ADMINISTRATIVE DEVELOPMENT PLAN AMENDMENT  
 FILE NO. 1000493-02236-00175  
 See note 7  
 Planning Director Date

1000493 Cottonwood Trails

SITE PLAN FOR SUBDIVISION AND BUILDING PERMIT

Consensus Planning January 10, 2001 Revised: February 13, 2002 Sheet 1 of 8

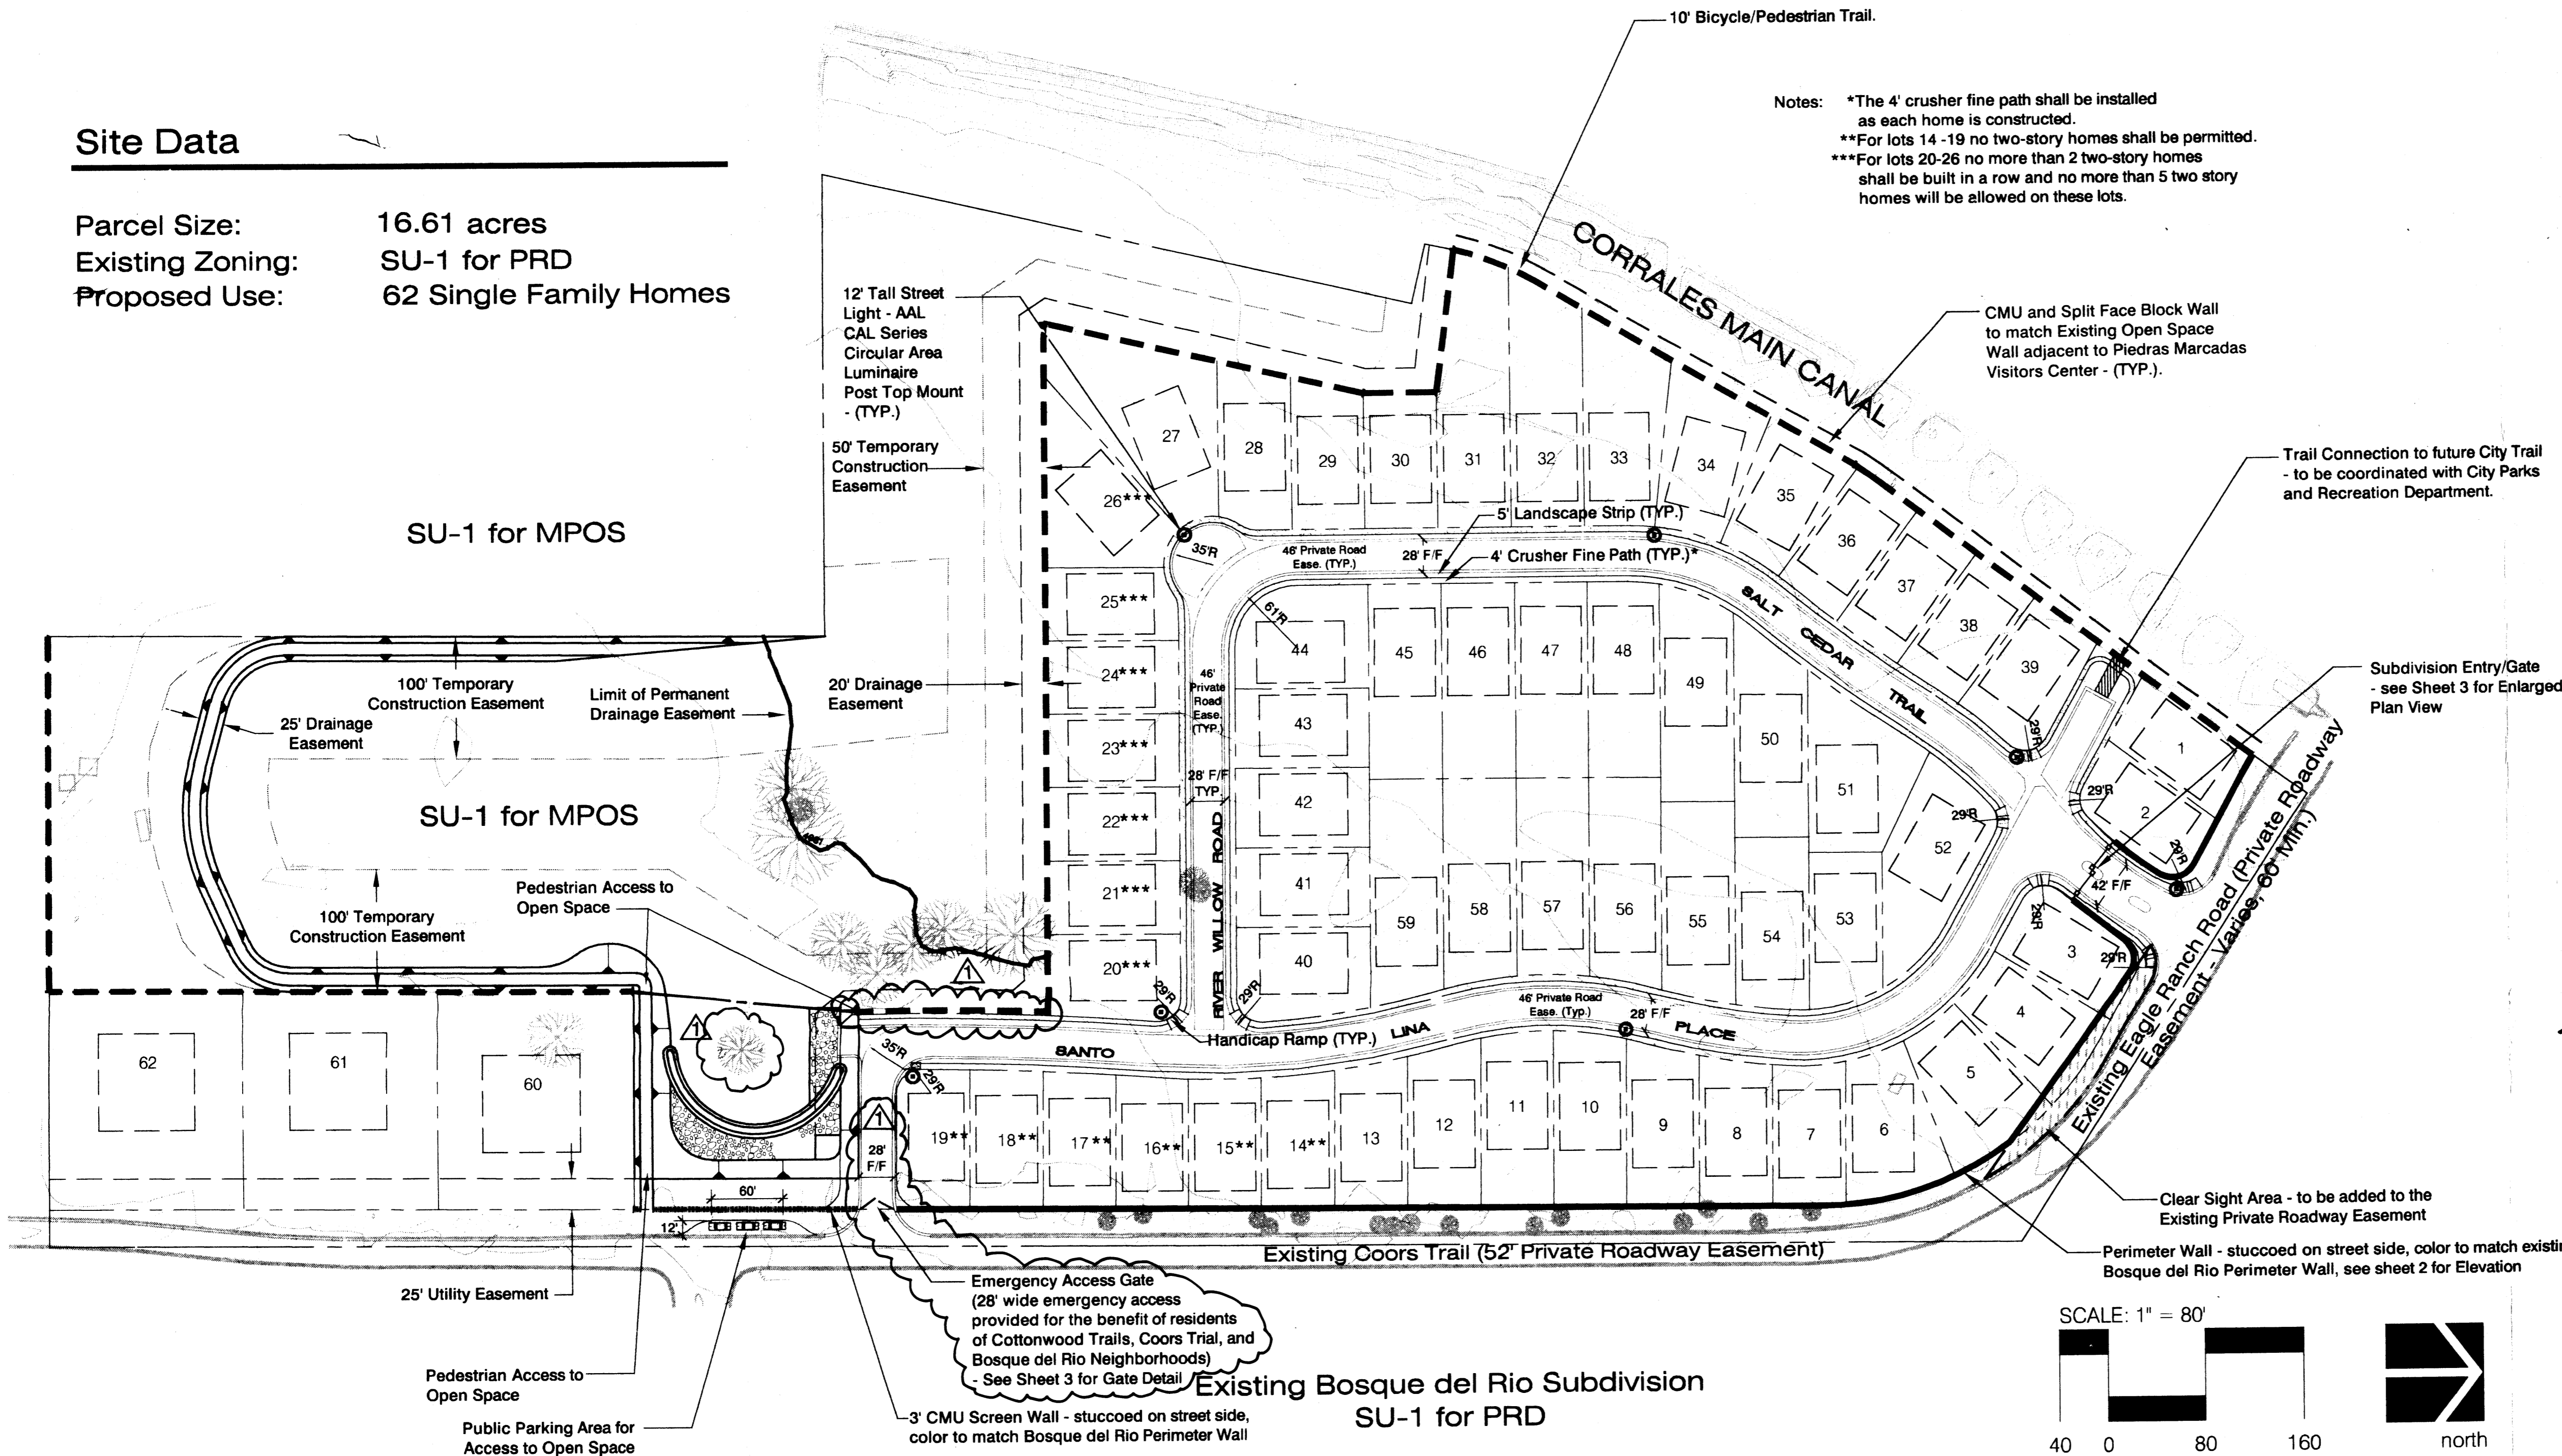
- Administrative Amendment
- Revised wall adjacent to City Open Space (Lots 18-26 & 60-62) to allow wrought iron view fencing (see new Sheet 3B).
- Added section of Open Space wall along the west side of Santo Lina Place (see Sheet 1).
- Revised note regarding existing cottonwood in the detention pond (see Sheets 2 & 3).
- Added Sheet 3B, Open Space Wall/Fence Plan.
- Modified Emergency Access per City DRC requirements (see Sheet 3).
